THEORY U DISTRICT

DESIGN RECOMMENDATION PACKET #2

#3034632-LU 4731 15TH AVE NE

VIEW AT ENTRY STOOP (UPDATED)

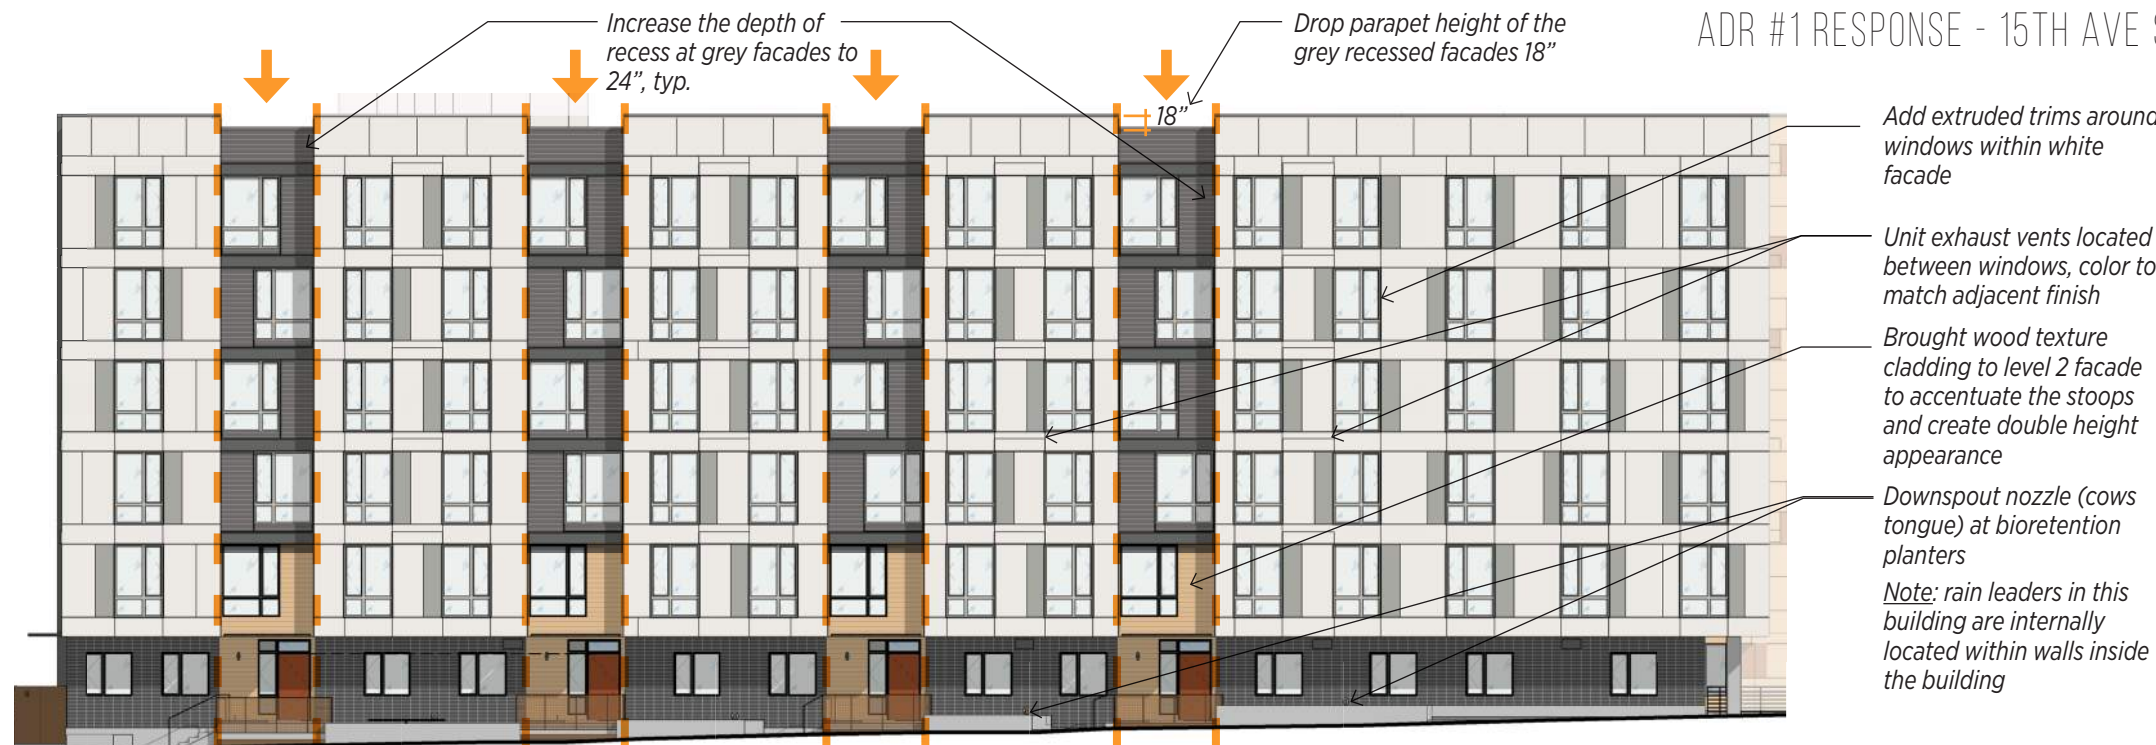
Staff echoes the Board's support for the stoops and residential character along the street-level. However, the design response to the Board's guidance regarding legibility and balancing street-level interaction with privacy concerns need to be further developed. Include the following studies with the next submittal:

- i. Adding canopies at the street level residential units
- ii. Adding raised planters placed in front of residential windows
- iii. Further demonstrate how the planting palette will survive long-term under the overhang condition.
- iv. Use black framed windows at street level

Following the staffs recommendation, steel canopies have been added above each stoop/patio at street level, to improve the legibility of the stoops. In addition, the windows at street level within the brick facade will include black framed windows.

The majority of the planting areas along this facade are bioretention planters. As such, they are frequently wet with rainfall collected from the roof. We propose raising the bioretention planter walls to an average of 12" (previously 6") high along the edge of the sidewalk, in order to discourage anyone from walking into them. This, coupled with the approximately 12" drop to the top of soil within the bioretention planters, provides a good physical separation from the unit windows and improves safety and privacy for street level units. 'Building up' these planters with taller walls would make the sidewalk feel narrower, and could also invite unwanted use in front of the units, both of which we want to avoid. Outdoor seating has been accommodated in the entry court area to the north.

The plants under the overhang will receive watering year-round in two ways: runoff from the roof as part of the bioretention system and automatic irrigation. The plants chosen for these planters are appropriate for this specific micro-climate and moisture condition.

Apply wood texture material on soffit and level 2 facade to further accentuate the entries

Add canopies over street level residential unit entries/patios

Provide black framed windows at street level

Raise the heights of bioretention planter walls in front of residential windows to average 12" above sidewalk

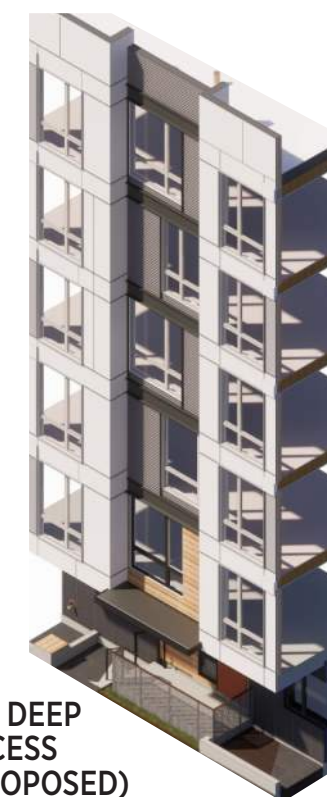
Staff remains concerned with the height, bulk, and scale of the south massing volume. Greater recess between the white plane and dark grey is needed to mitigate the long flat facade. Specifically, a 1' recess is not sufficient to mitigate the bulk and scale of this long facade. Include the following studies with the next submittal:

- Drop the parapet height of the white or grey facades
- Recess the windows within the white areas
- Increase the recess to min 30" depth
- Lift the bays up for the four southern bays
- Include vents and down spouts that are integrated into the design

A 24" deep recess, which is doubled from previously proposed 12" recess, is proposed between the white and grey facade to improve the south massing modulation.

The design team conducted a three dimensional study of staff recommended 30" recess at grey facades. Our study shows that increasing the recess depth to 30" significantly reduces the unit's floor area and negatively impacts the functionality of the living rooms. In addition, the 6" difference in recess depth is fairly imperceptible from exterior modulation stand point (see diagram on the right).

Therefore, the design team believes that the proposed 24" recess creates a nice balance between improving massing modulation and maintaining the function and livability of the residential units.

WEST ELEVATION (UPDATED)

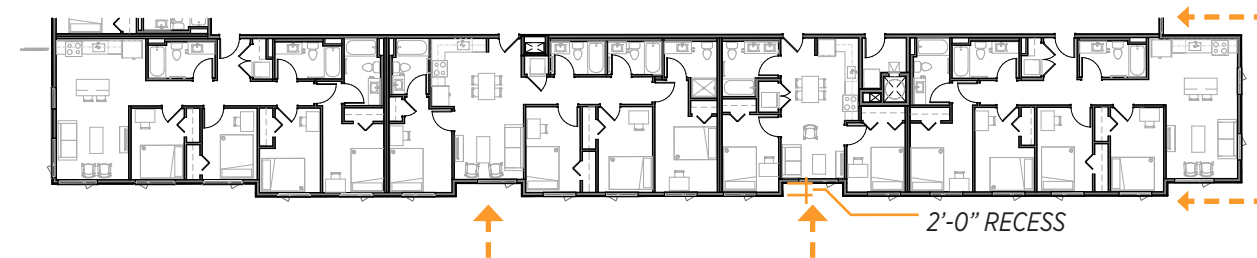
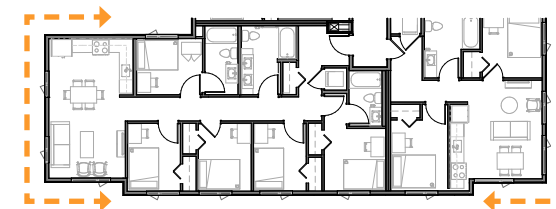
As previously commented by Staff, the alley requires further relief beyond one small recess. With the next submittal staff expects to see the alley design resolved in a manner more consistent with the street facing facades. Specifically, resolve the alley to more clearly relate to the established architectural language applied to the south massing structure.

Introduce strategically placed 24" deep modulations along the west facade

Apply the modulation strategy around into the courtyard and south facades

In response to staff's comment, the design team has added several strategically placed 24" deep recesses along the alley facade to match the recess on the south massing along 15th Ave. The parapet height of the recesses is also dropped 18" similar to the southwest facade to further improve the facade modulation. These recesses are aligned with level 1 and 2 exterior walls below and are carried around into the courtyard and south facades.

PARTIAL PLAN - MAIN ENTRY (UPDATED)

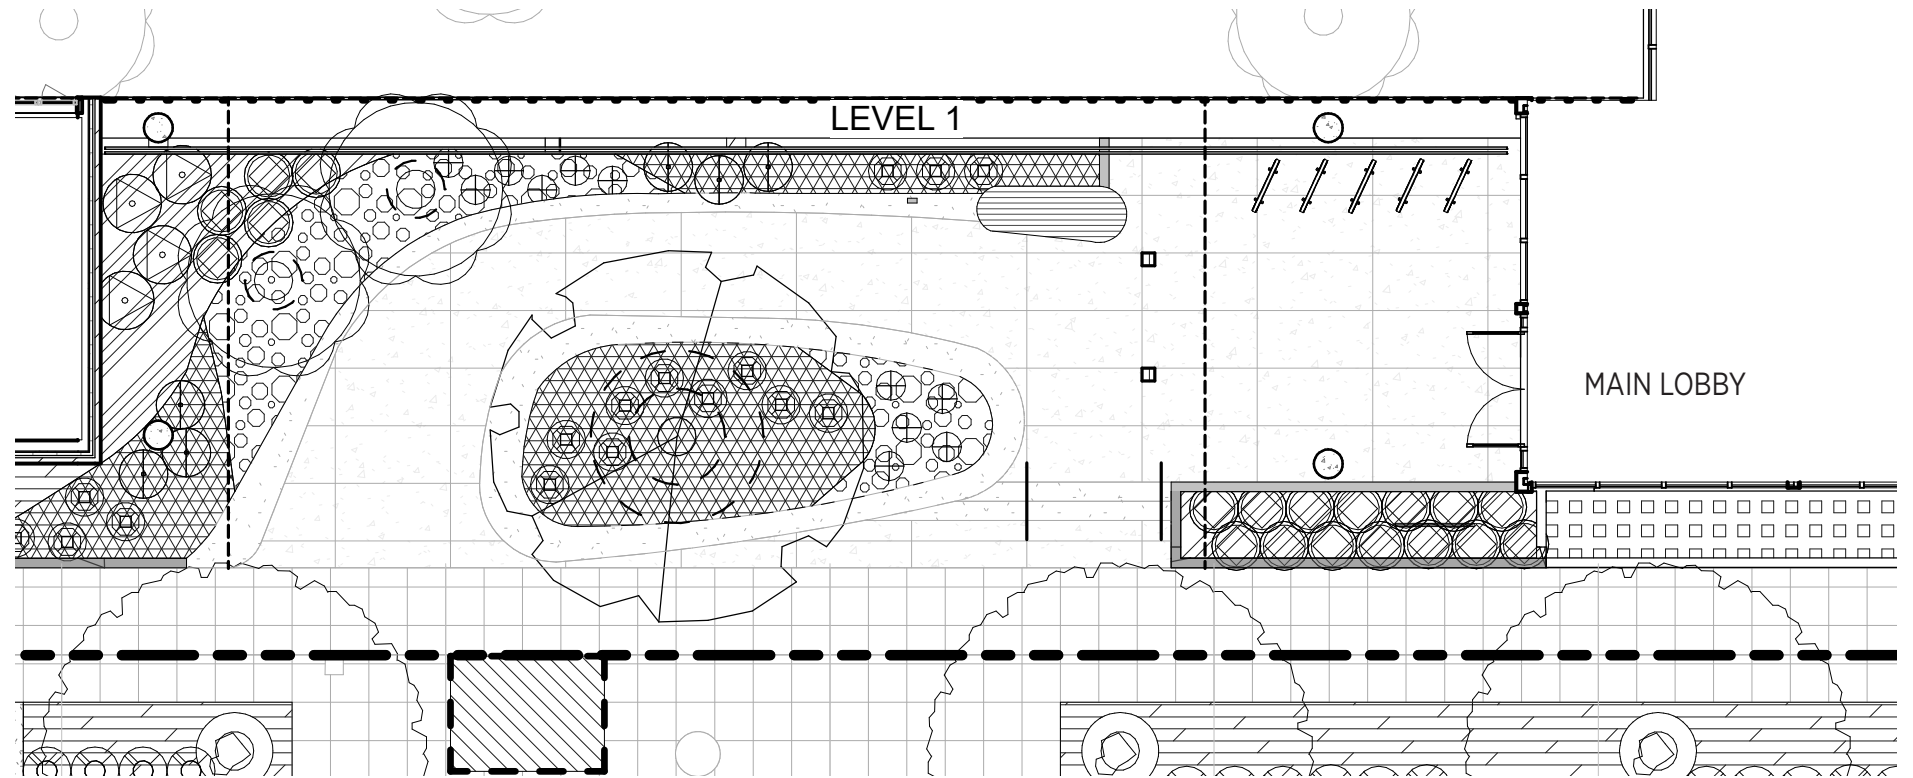
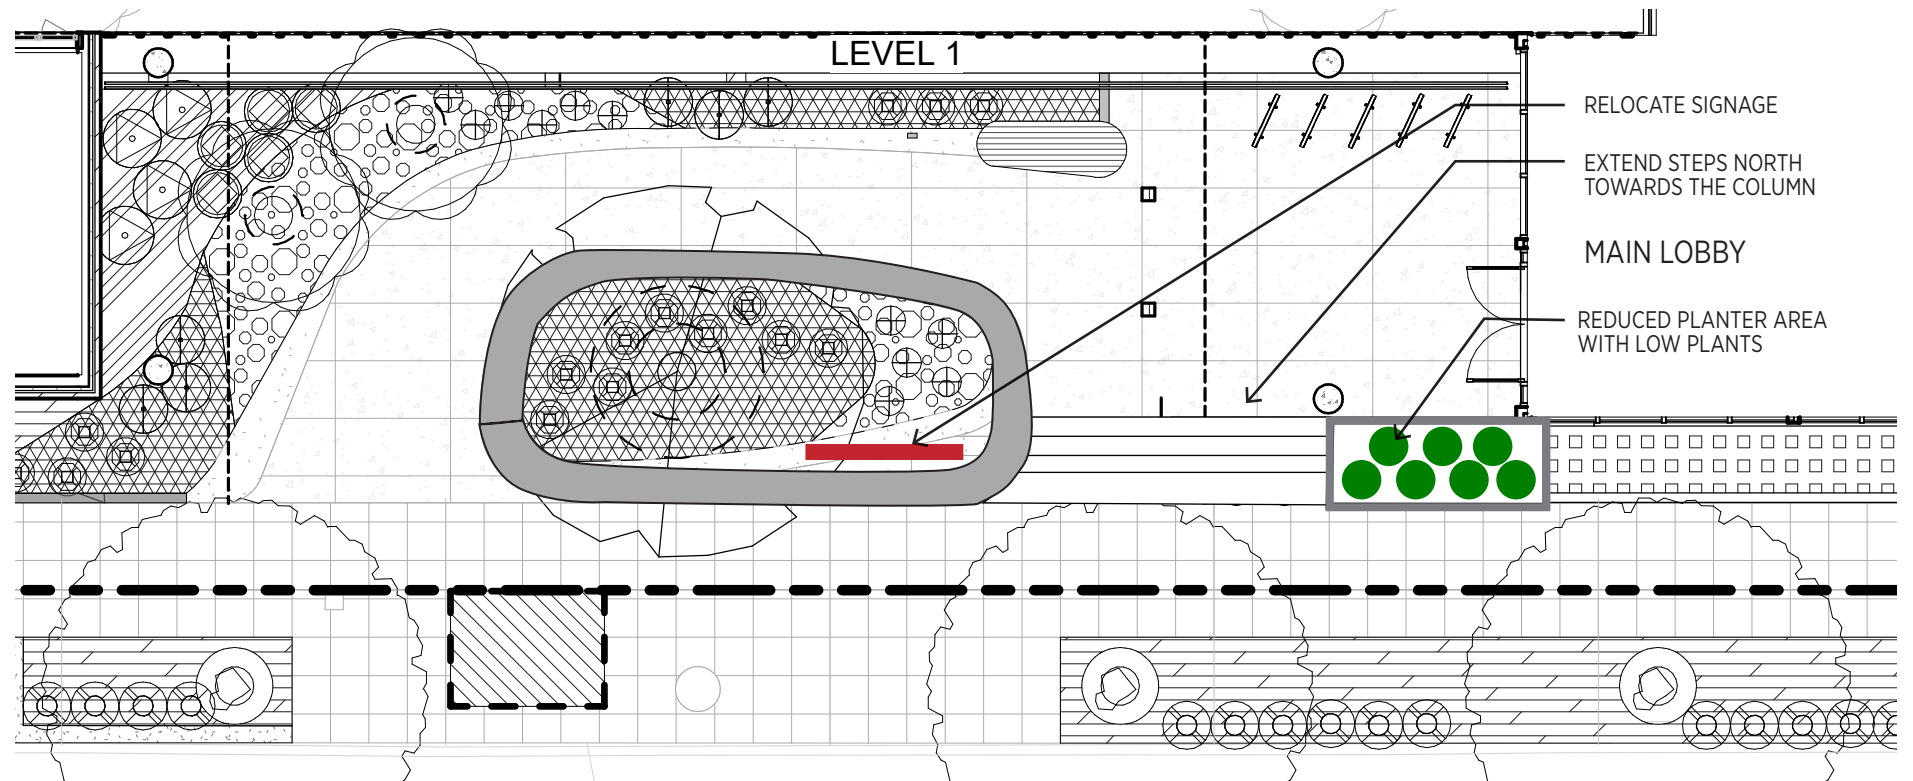
Staff is concerned with legibility of the main entry due to the combination of entry location (pulled away from the street) and further closing off the entry with the seat wall and landscaping. Revise the entry configuration to improve the legibility of the main entry.

To address staffs concern, we propose extending the steps further to the north, reducing the size of planter area next to the main entry door, and relocate the signage in order to improve the visual connection and visibility of the main entry.

There is approximately 22" grade differential between the sidewalk and the finish floor of the lobby. The reduced planter area with low planting can still accommodate the grade transition while allowing better visibility to the entry. Extending the steps to the north to be approximately 14' wide improves visual and physical relationship between sidewalk and the lobby entrance.

REDUCED PLANTER AREA WITH LOW PLANTS

EXTEND STEPS NORTH TOWARDS THE COLUMN

RELOCATE SIGNAGE
